**Request for Additional Information No. 378(4409, 4513, 4490), Revision 2
Supplement 3**

U. S. EPR Standard Design Certification

Docket No. 52-020

**QUESTIONS for Containment and Ventilation Branch 1 (AP1000/EPR Projects)
(SPCV)**

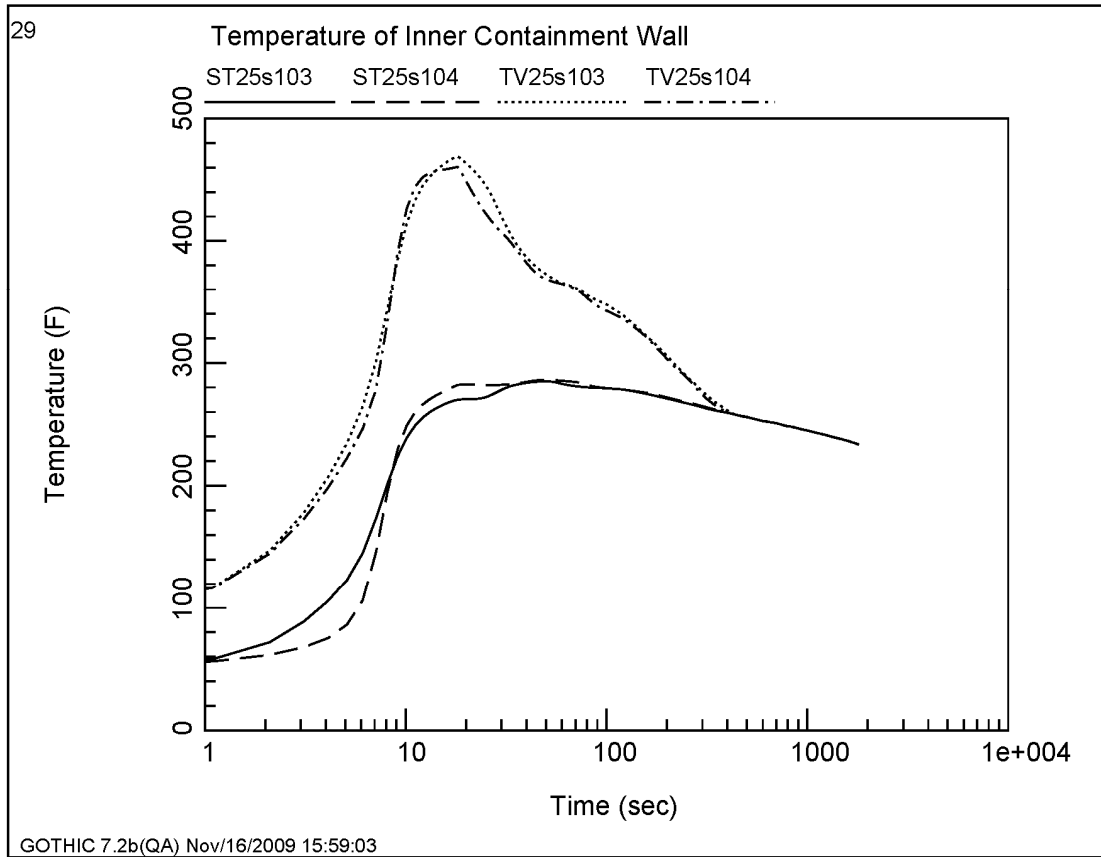
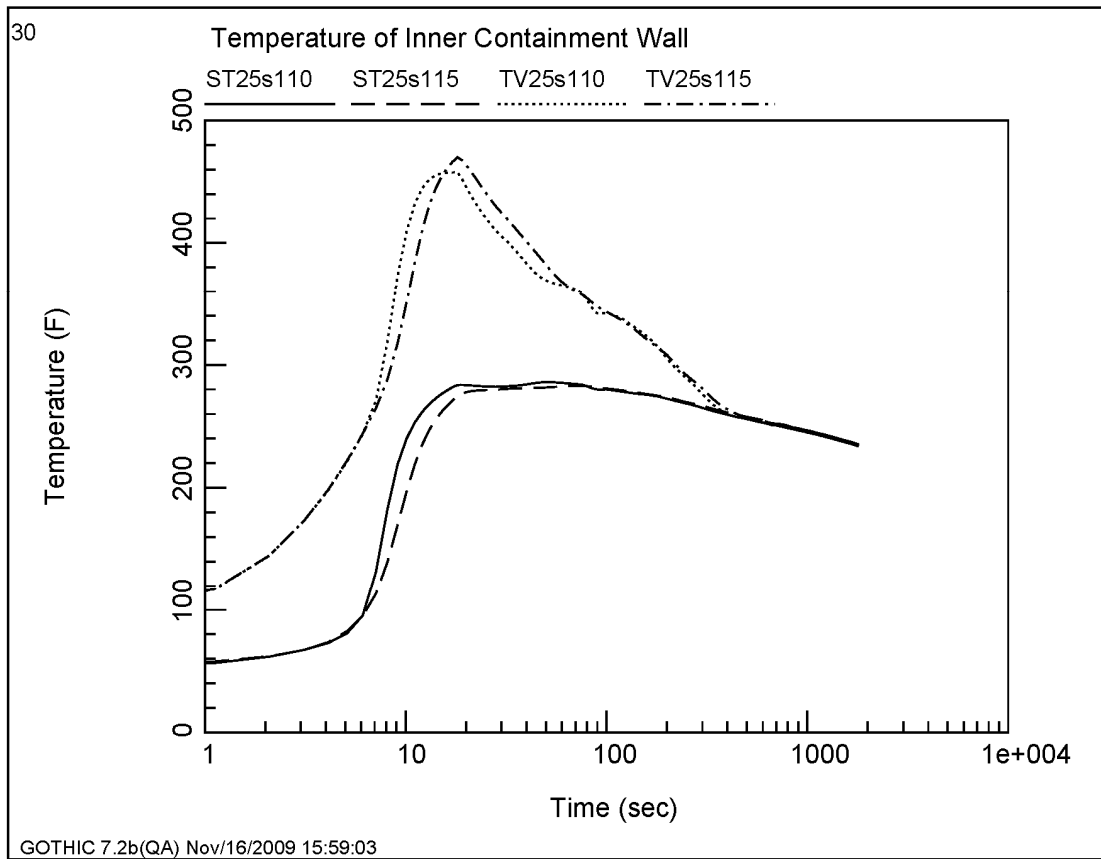
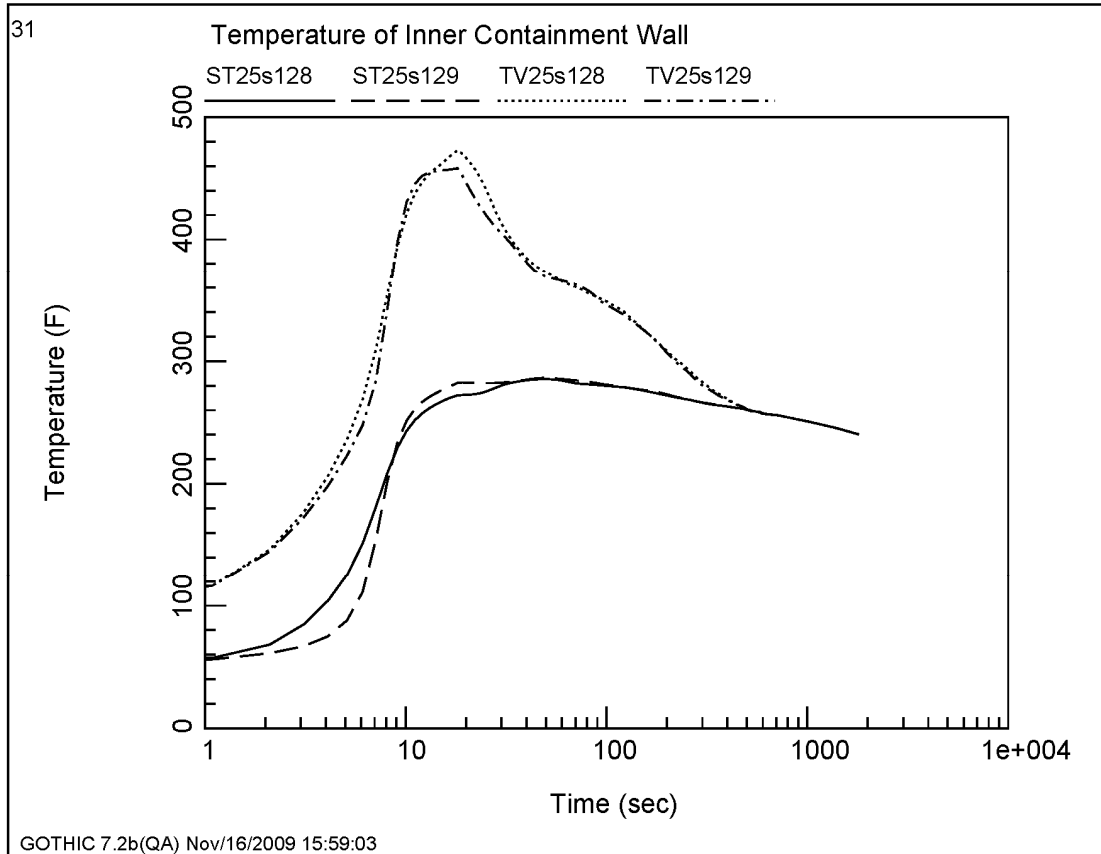
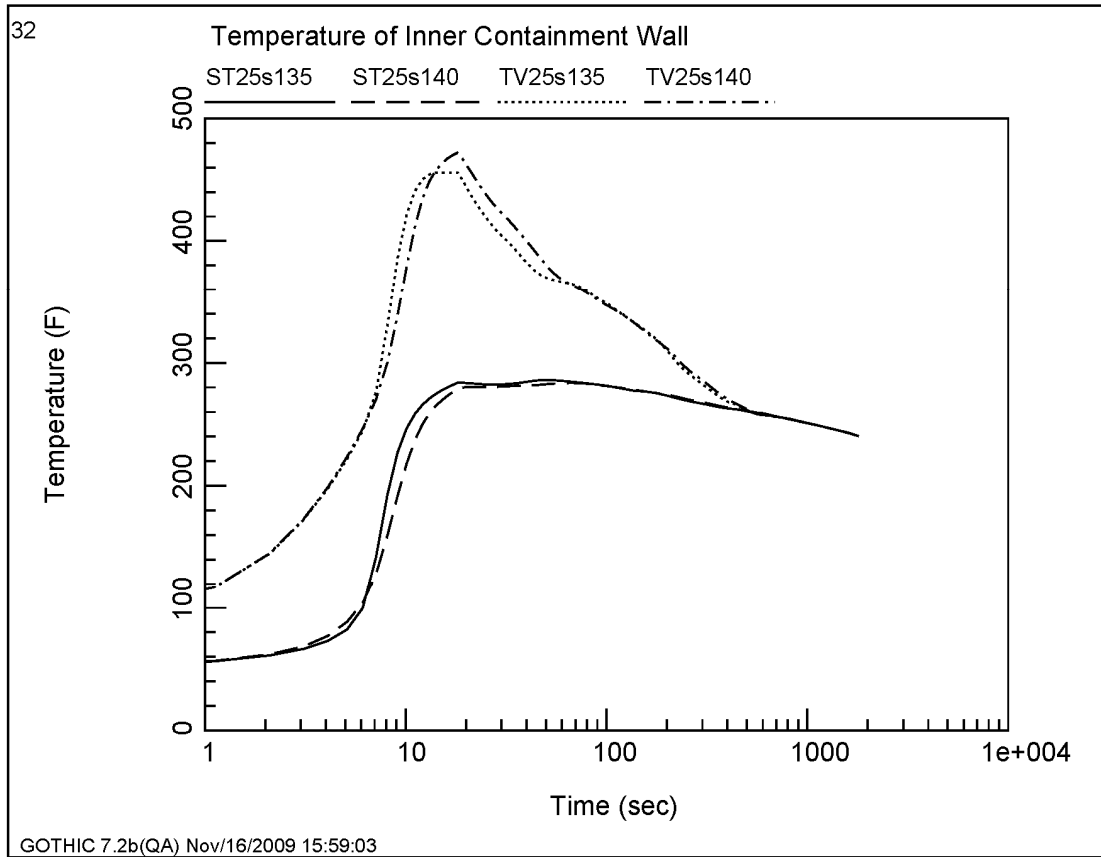
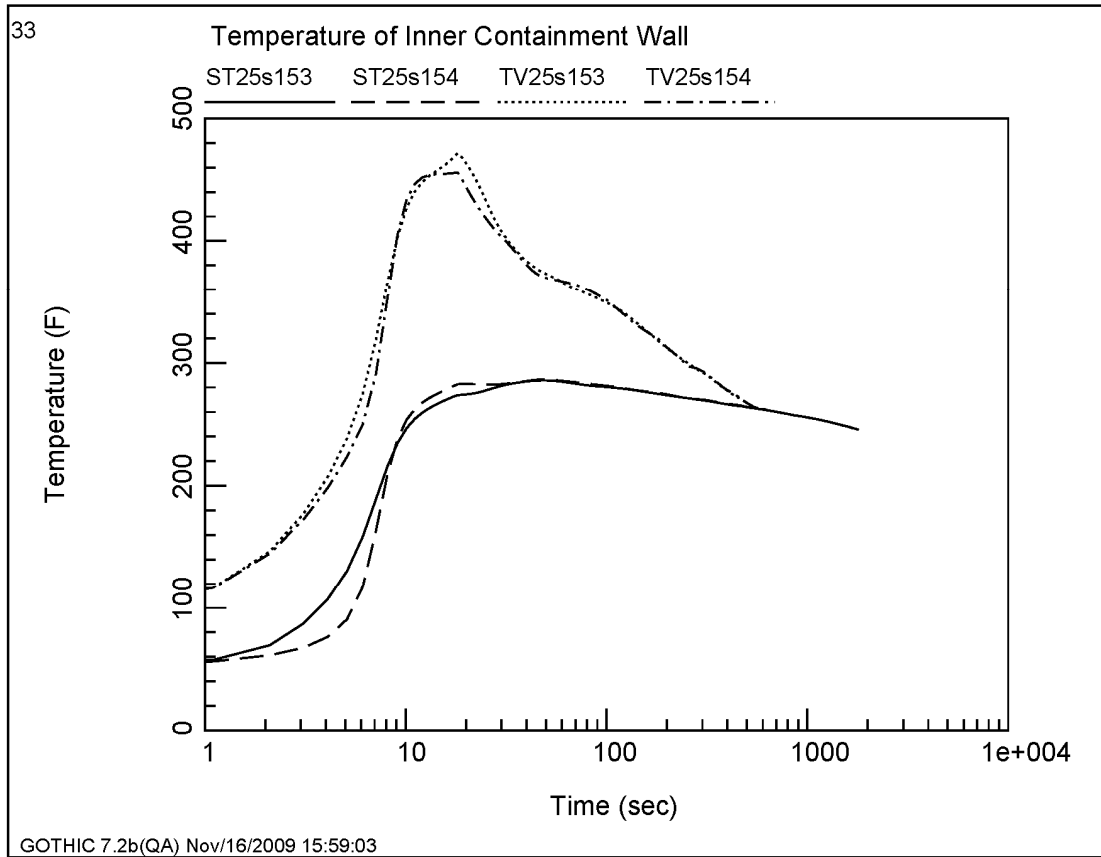
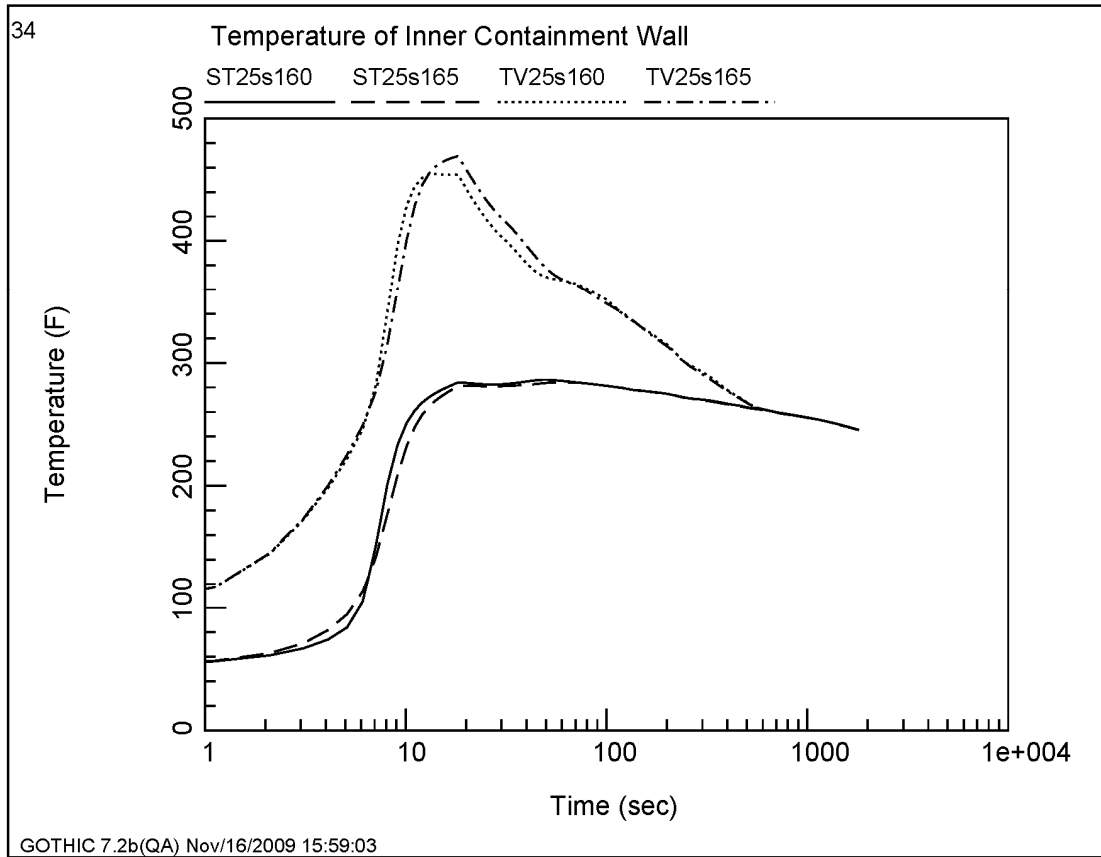
- f. A time history temperature plot for the inner containment shell (note sub-divided or lumped parameter node in figure) in proximity to the location of maximum atmospheric (gas) temperature.

- f) The time history atmospheric temperature plots for the inner containment shell in proximity to the location of maximum atmospheric temperature are given in Figures 06.02.01-89-29 through 06.02.01-89-36.

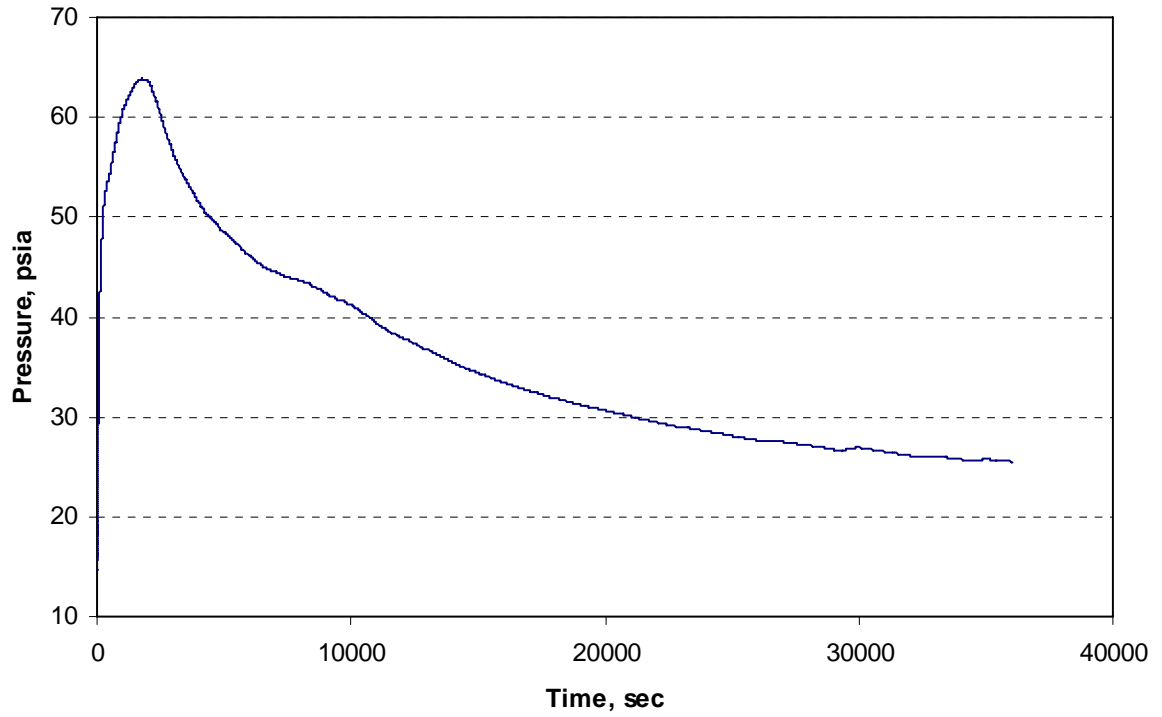
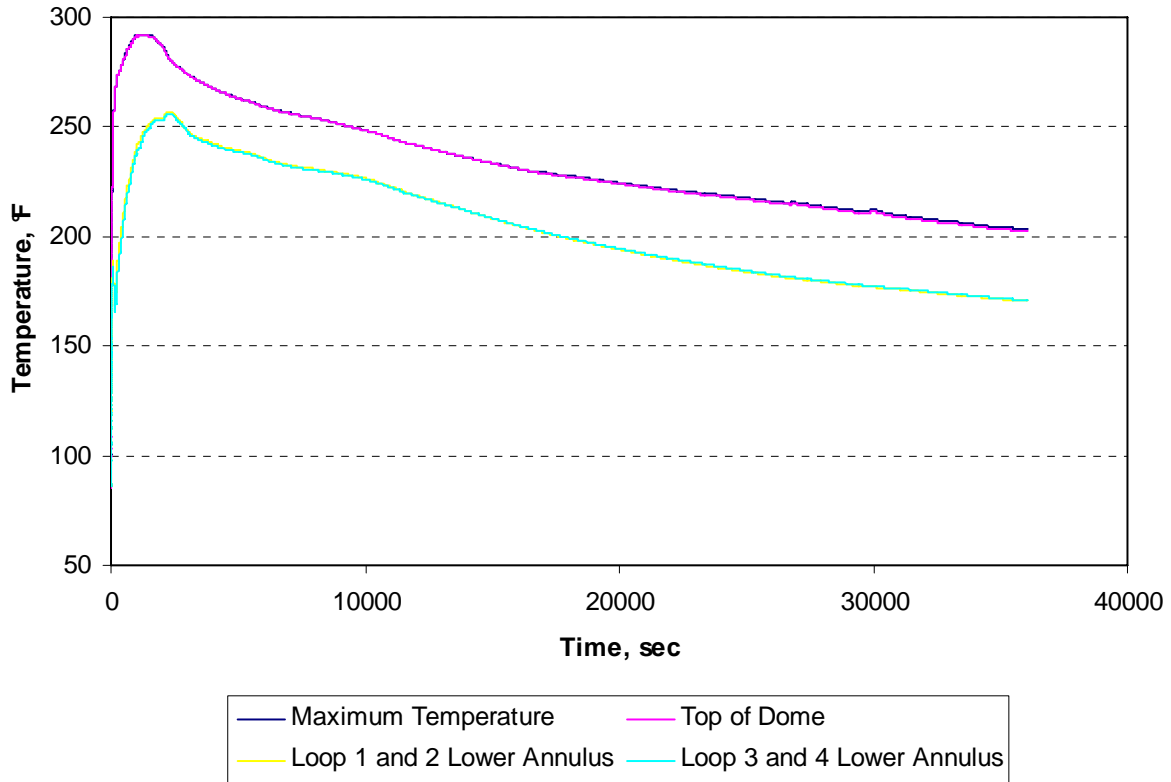
- a. Figures showing for a typical small break, the containment pressure and temperature for the duration of the analysis. Temperature curves should be included for the maximum temperature node, for the top of the dome and for the two lower annulus nodes.
- b. Figures comparing the peak pressure curves and peak temperature curves of the five cases analyzed.
- c. Provide the result from a postulated small break in the Accessible Space. Select one of the highest pipe elevations. Provide the same curves as requested for the typical small break case above under sub-item a.
- d. Provide a discussion on the performance of the CONVECT system during small break accidents. Show that sufficient vent area exists between the two rooms of the containment. Justify opening of the foils for breaks within the Equipment Room and the Accessible Space.

- a) The containment pressure and temperature response for SBLOCA are shown in Figure 06.02.01-90-1 and Figure 06.02.01-90-2, respectively. The case chosen was a 9" cold leg pump discharge (CLPD) break, which resulted in the highest peak pressure and temperature of the small breaks. The pressure curve was taken from the node in the GOTHIC model that had the highest peak pressure, which was the in-containment refueling water storage tank (IRWST) room. The pressure distribution is almost uniform throughout the containment. The difference in peak pressure between the top of the dome and the IRWST is about 0.3 psi.

The temperature curves were taken from four different nodes:

- Location of maximum peak temperature.
- Top of the dome.
- Loop 1 and 2 lower annulus rooms.
- Loop 3 and 4 lower annulus rooms.

The location of the maximum peak temperature was the subdivided cell underneath the top of the dome.
